STATE OF TENNESSEE DEPARTMENT OF TRANSPORTATION DESIGN DIVISION NASHVILLE, TENNESSEE 37243-0348

INSTRUCTIONAL BULLETIN NO. 13-1

Regarding New and Revised Standard Drawings

Effective immediately, the following Standard Drawings are new or revised and Section V of the Design Guidelines is revised for this update.

5-27-95 D-CB-12S

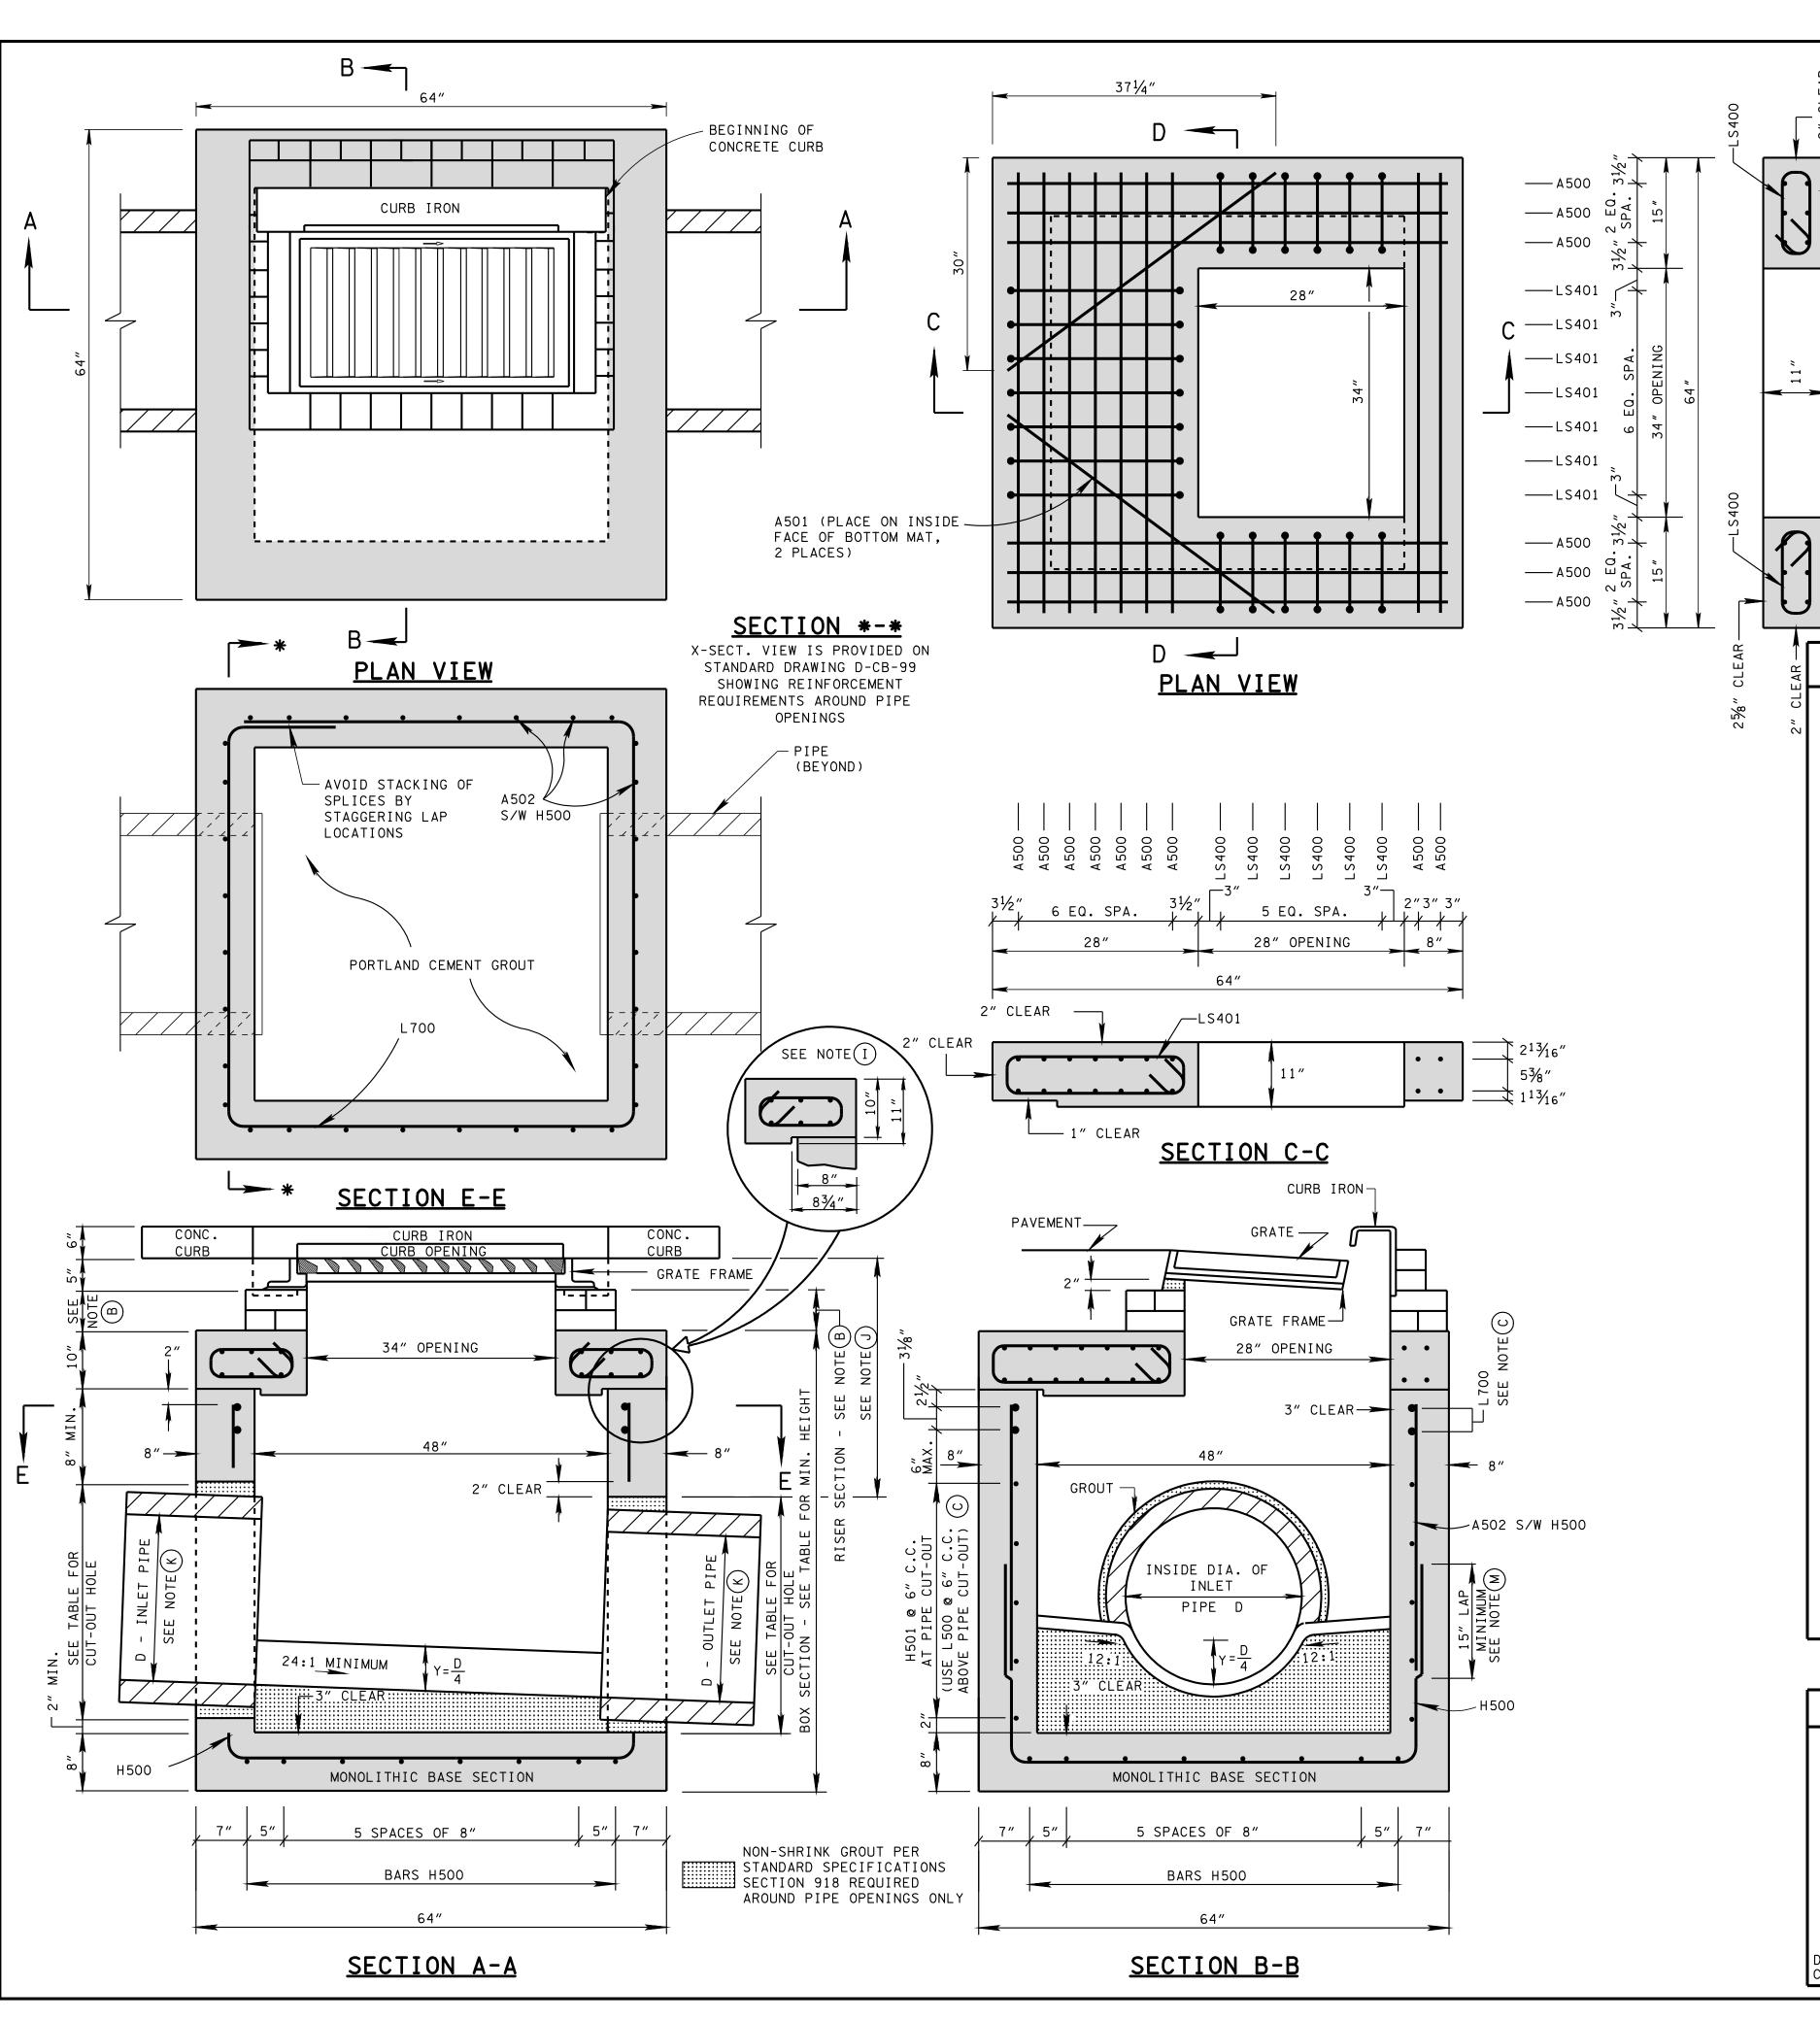
- ☐ REV. 5-27-01: CHANGED PAY ITEMS IN GENERAL NOTE ① ADDED CATCH BASIN MAXIMUM DEPTH NOTE.
- ☐ REV. 7-29-02: CHANGED ASTM SPECIFICATION IN GENERAL NOTE ©
- REV. 8-01-12: REVISED CATCH BASIN FOR COMPLIANCE WITH AASHTO LRFD BRIDGE DESIGN SPECIFICATIONS, 4TH EDITION WITH INTERIMS. REVISED REINFORCING, GENERAL NOTES, LEGEND AND ADDITIONAL MISC. DRAFTING
- ☐ REV. 9-24-12: MODIFIED TOP SLAB AND MINIMUM DEPTH.
